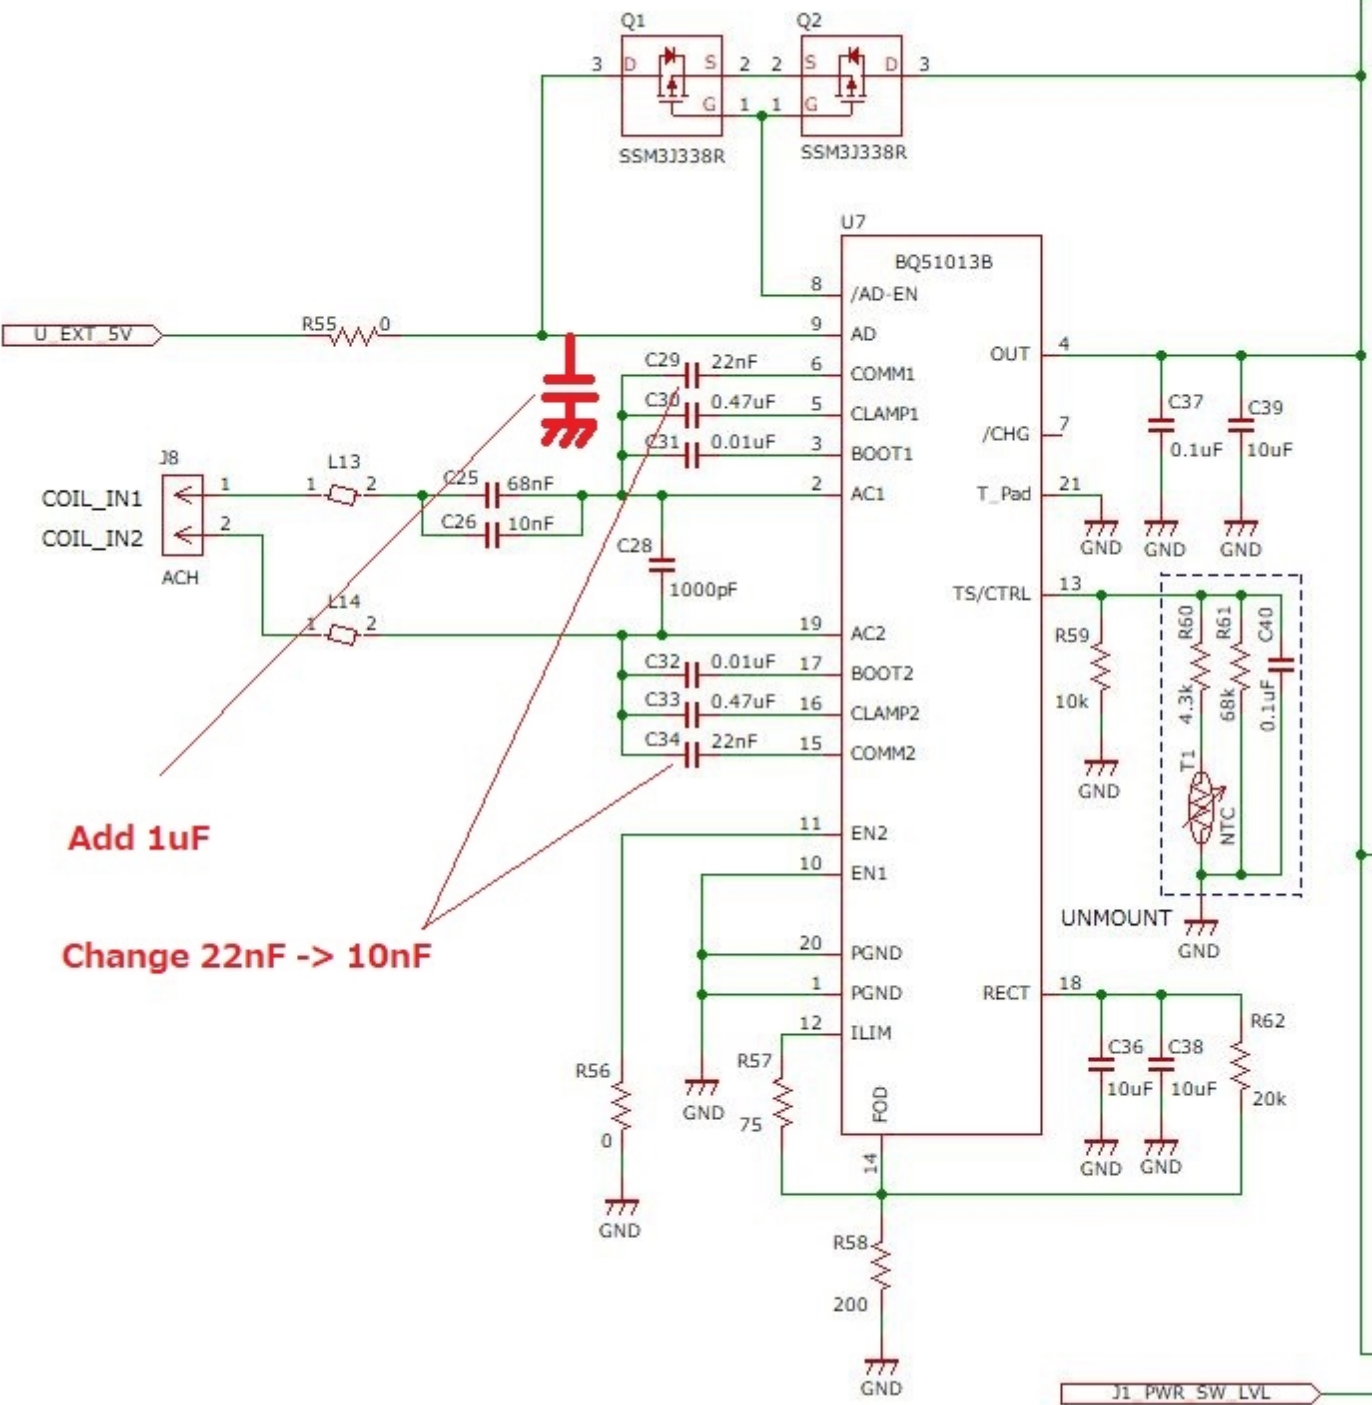
Add 1uF

Change 22nF -> 10nF
